To: T10 Technical Committee
 From: Amr Wassal, PMC-Sierra (amr_wassal@pmc-sierra.com)
 Stephen Finch, STMicroelectronics (steve.finch@st.com)
 Date: 20 September 2006
 Subject: 06-324r3 SAS-2 Modifications to the SAS Speed Negotiation

Revision history

Figure 123 — SAS SNW-3

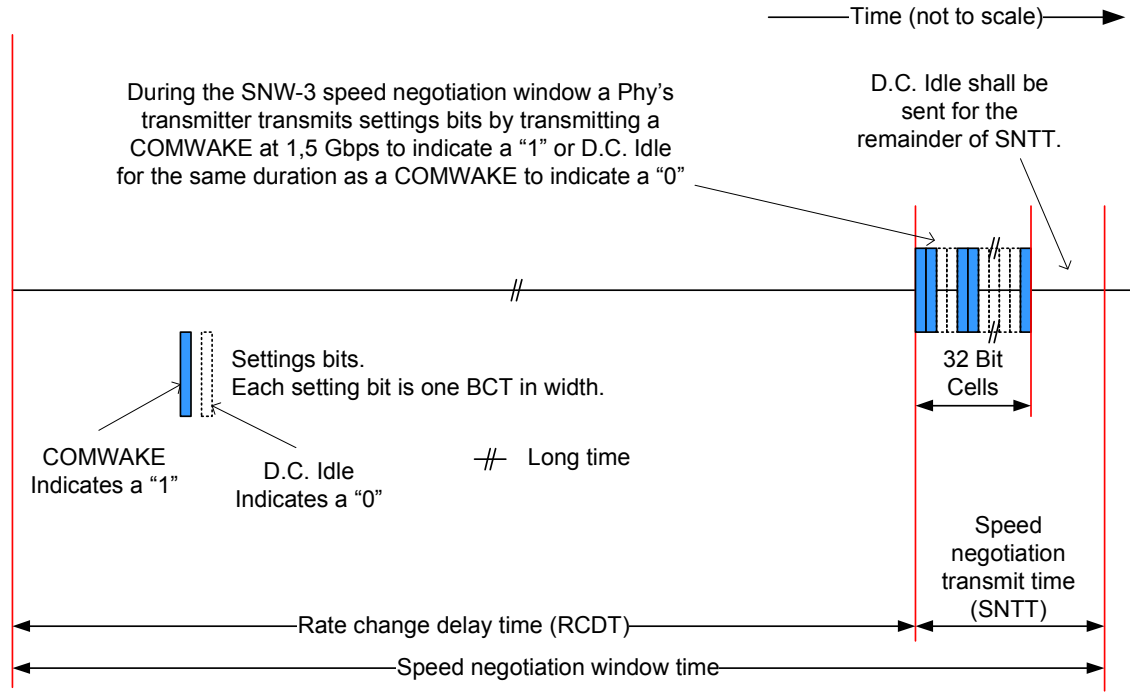
<In figure 123, added "Each setting bit is one BCT in width." to "Settings bits" label.>

Figure 124 — SAS Train-SNW

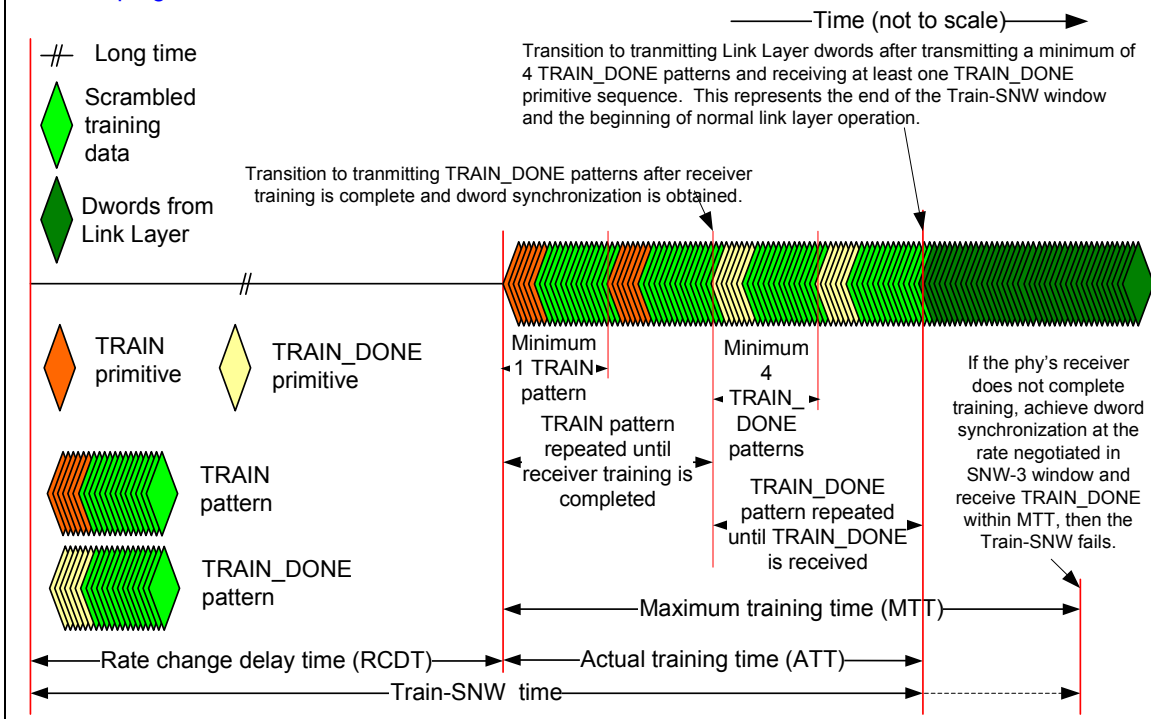
<<Figure 124. Change label on light green diamond from "Scrambled data" to "Scrambled training data"; shortened red marker line at end of MTT so that it doesn't reach the dark green diamonds; moved the comment that points to the end of MTT to below the dark green diamonds; and added

“This represents the end of the Train-SNW window and the beginning of normal link layer operation.”
to the top right text block.>>
